SUPPLEMENTAL FINAL ENVIRONMENTAL
IMPACT STATEMENT

ALBANY PORT DISTRICT COMMISSION
PORT OF ALBANY EXPANSION PROJECT

TOWN OF BETHLEHEM, NEW YORK

Date: February 2022

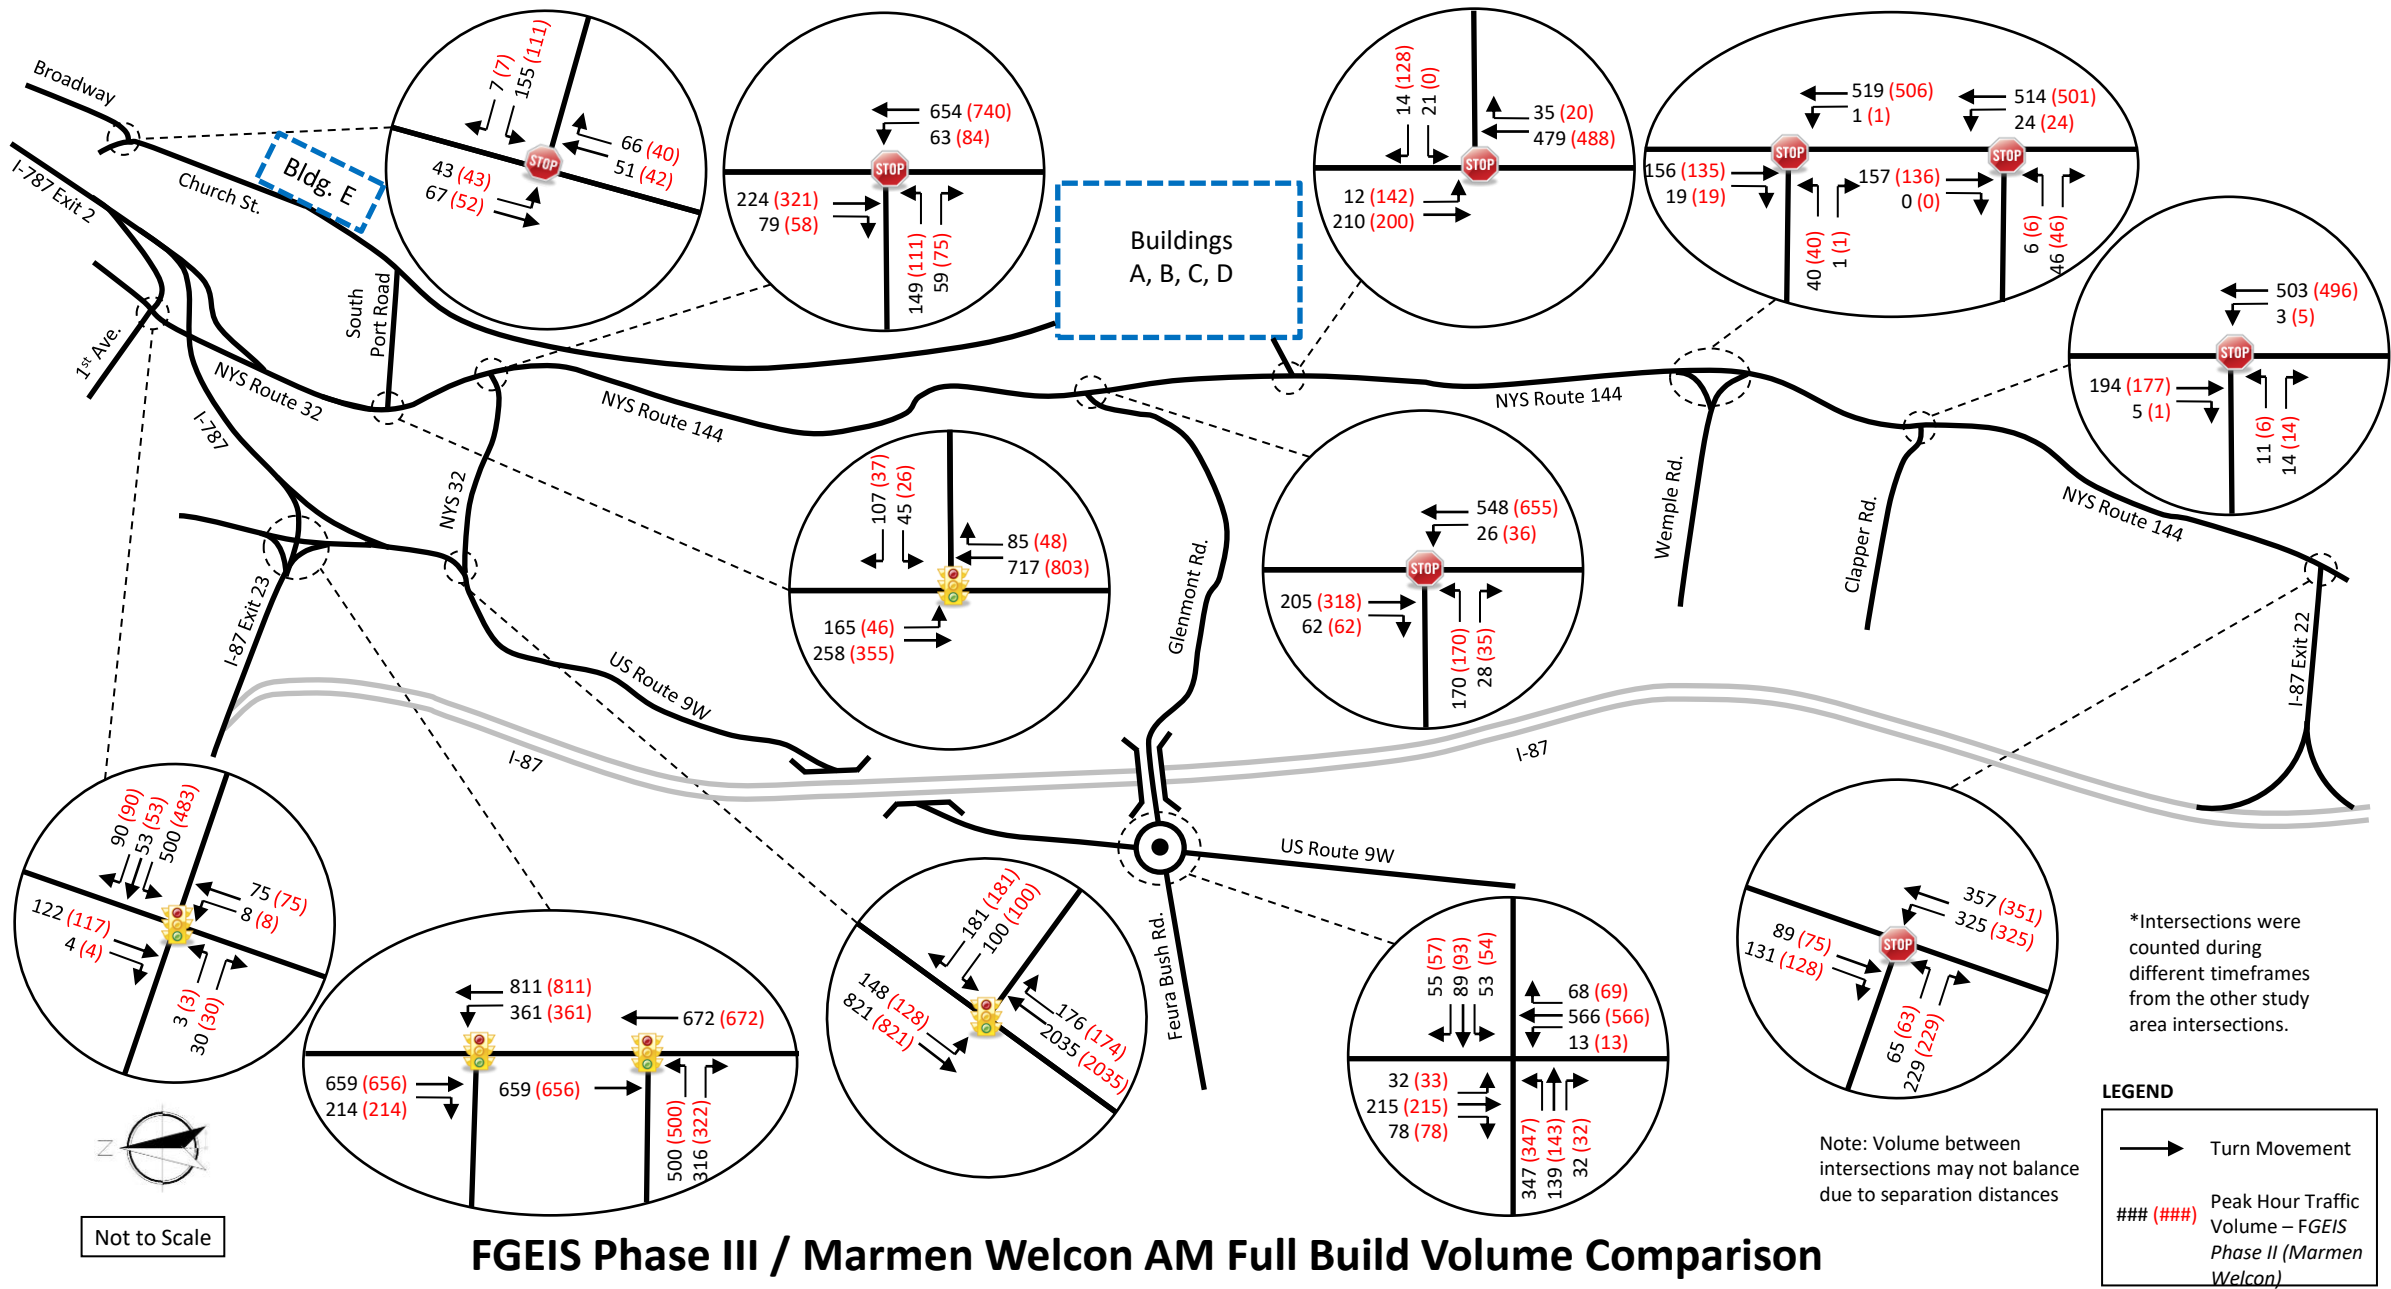
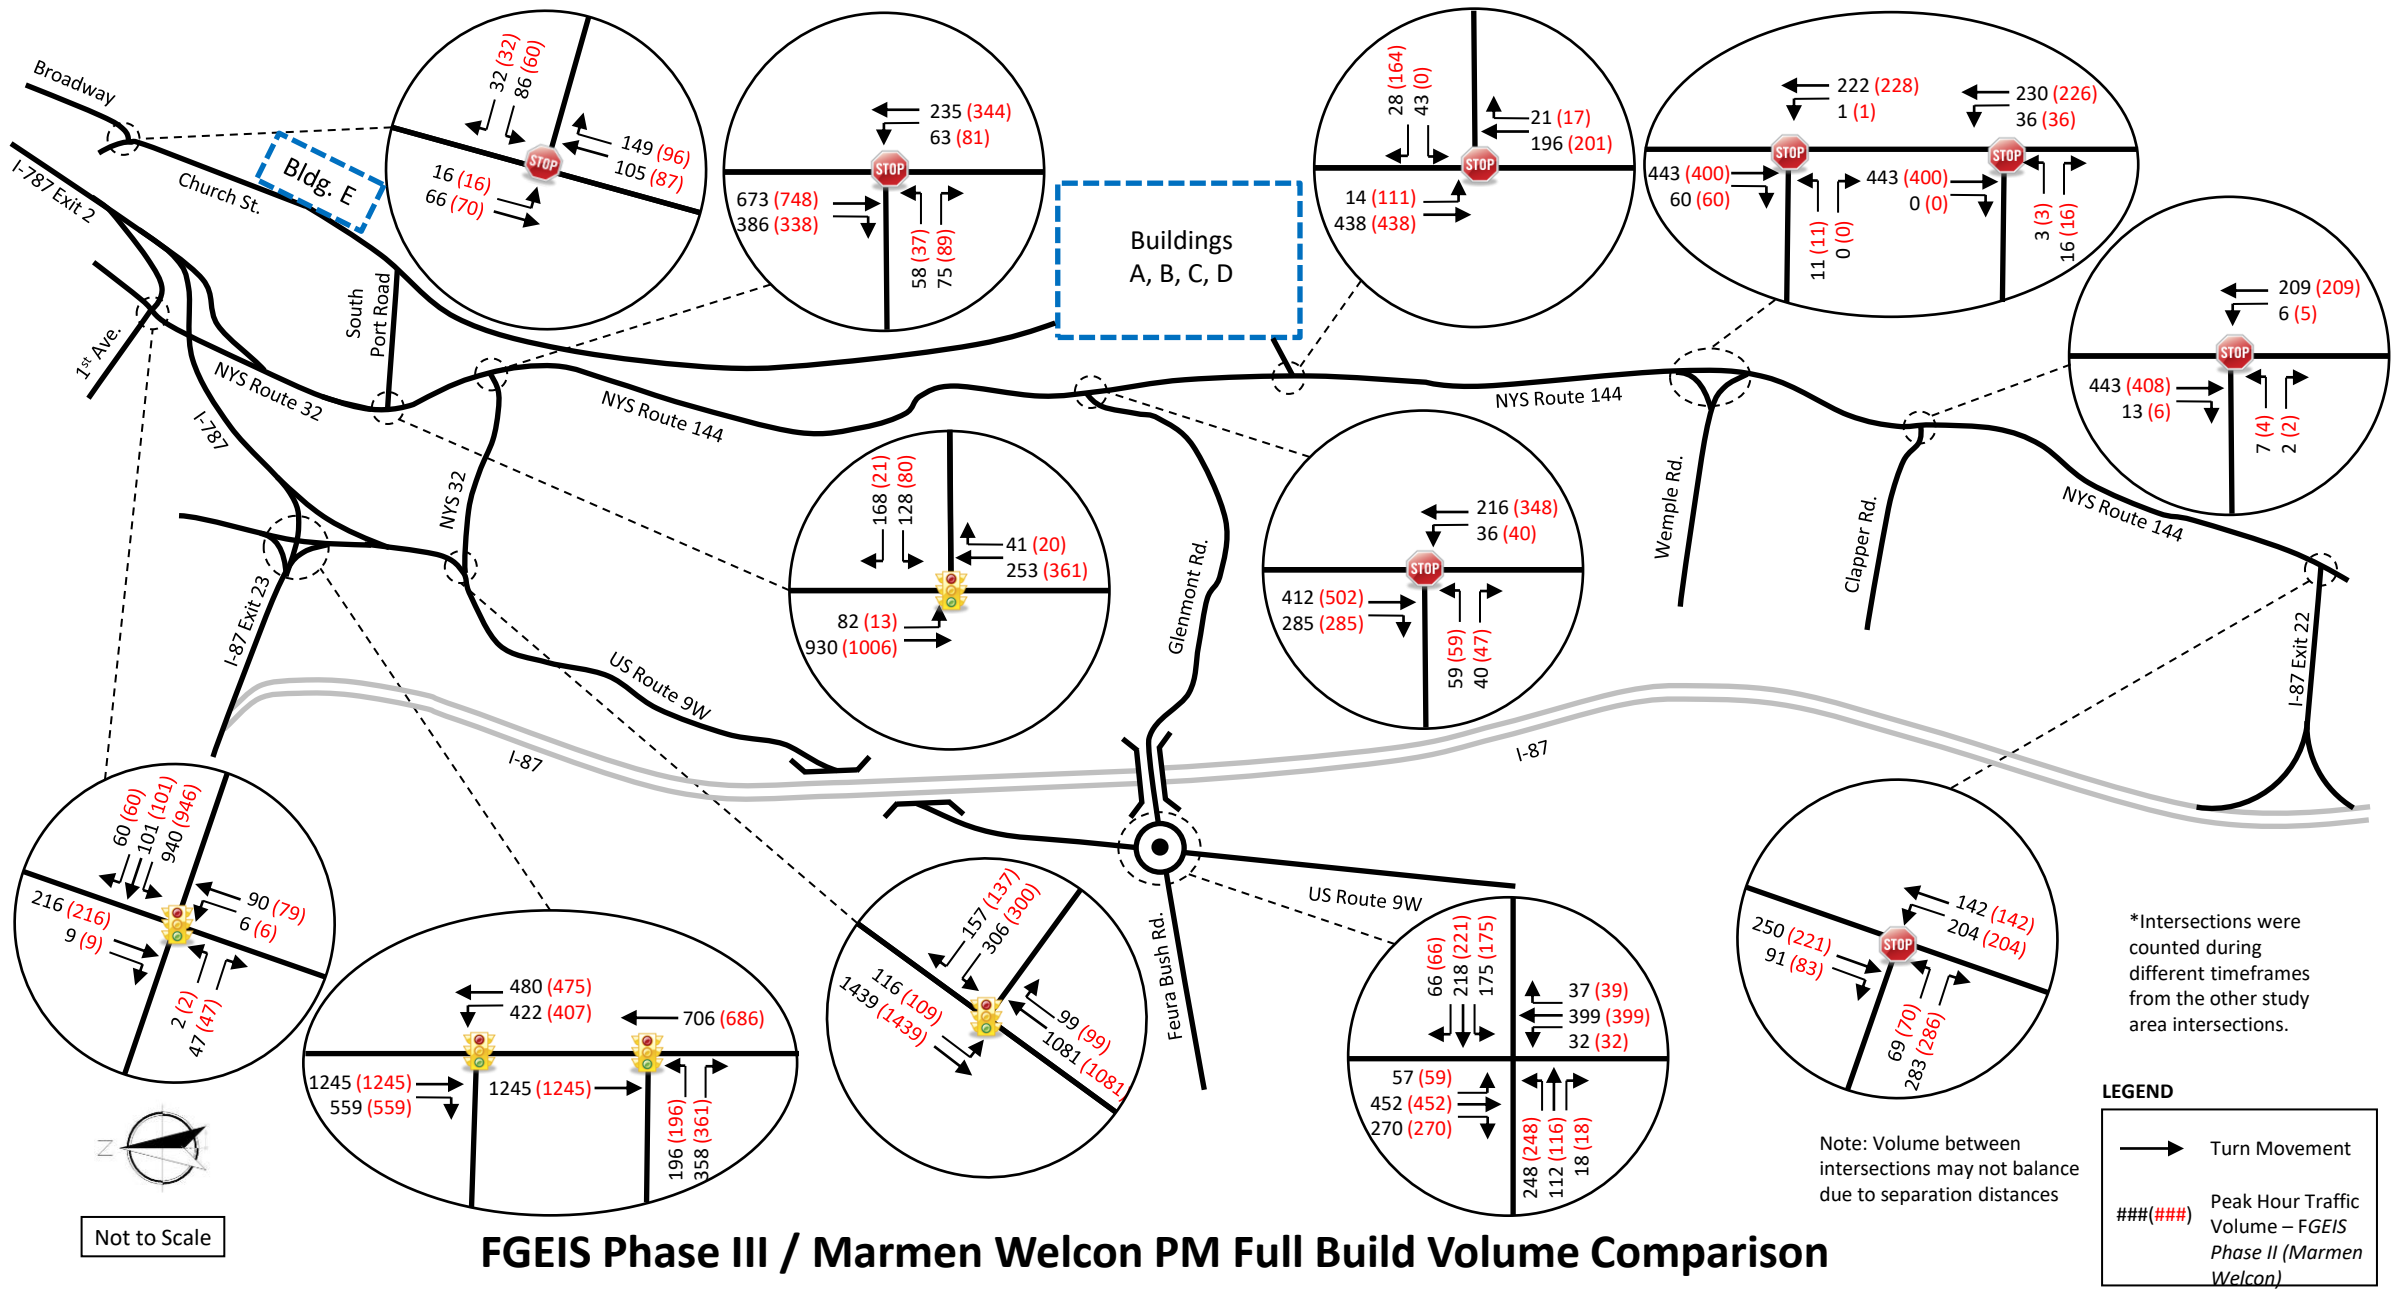
Comment B-5: Figures 2A and 2B: The difference in volumes between intersections along the NYS Route 32 and 144 corridor do not match. It is understood the volumes will not balance due to data collected at different times, but the differences should match if all that has changed is the trip volumes. Volumes should be verified and updated accordingly.

Response: The volumes in Figures 2A and 2B were updated and are located in Appendix CC. The through volumes at the proposed site driveway on NYS Route 144 were reduced back to the GEIS values to remain consistent with the previous analysis. The revised volumes resulted in a negligible impact to the capacity analysis results as shown in the table below. All the previous conclusions and recommendation within the traffic impact study remain valid.

Employee Trip Assignment

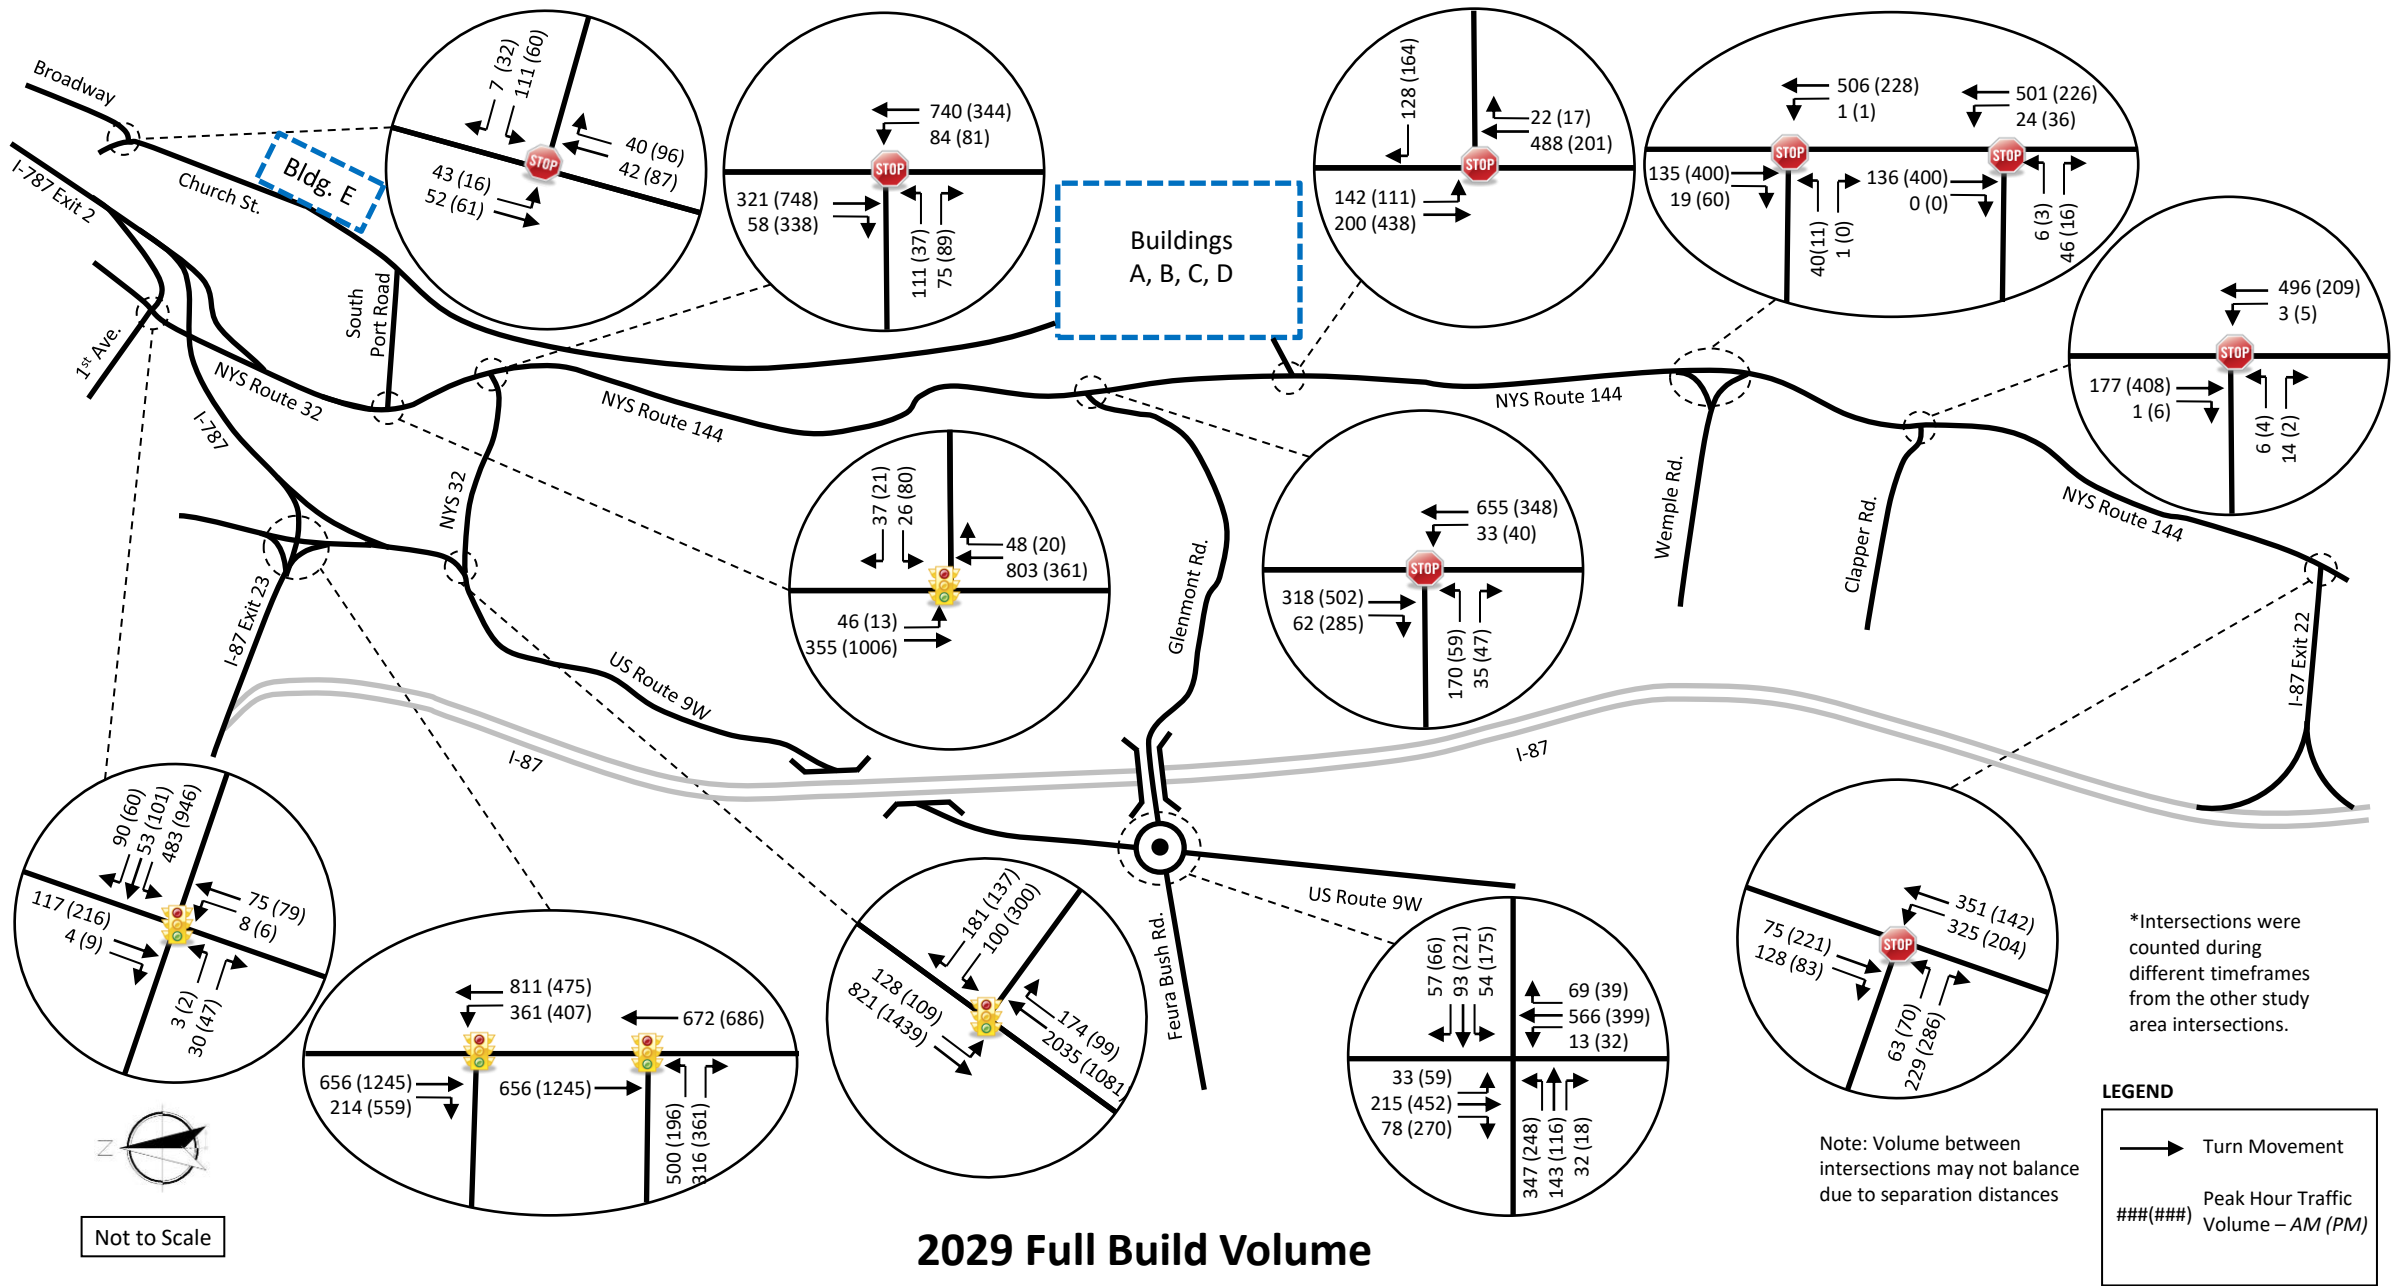
Comment B-9: Page 14, Figure 6: Modify legend to include AM and PM volume designation.

Response: The legend has been modified to clarify the AM and PM volumes shown on Figure 6, which is included in Appendix CC.
